**RE: Revision to main and second floor framing for Lot # 116 Woodside Ridge – 2134 NW Killarney Lane Lee's Summit MO 64081 – Permit # PRRES20211584**

This letter addresses the revision to the main floor framing for Lot #116 Woodside Ridge.

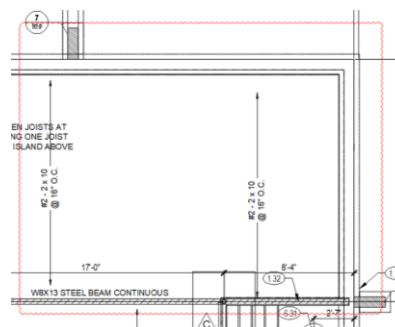
- Floor joists spanning approximately 6.5' in garage shall be Douglas Fir Larch #2 2x10 at 16" oc as shown in image below.
- Floor joists have standard Dead=10 psf and Live = 40 psf loads in addition to a point load from 2<sup>nd</sup> floor roof and exterior wall and a point load from main floor roof truss bearing on floor joists.
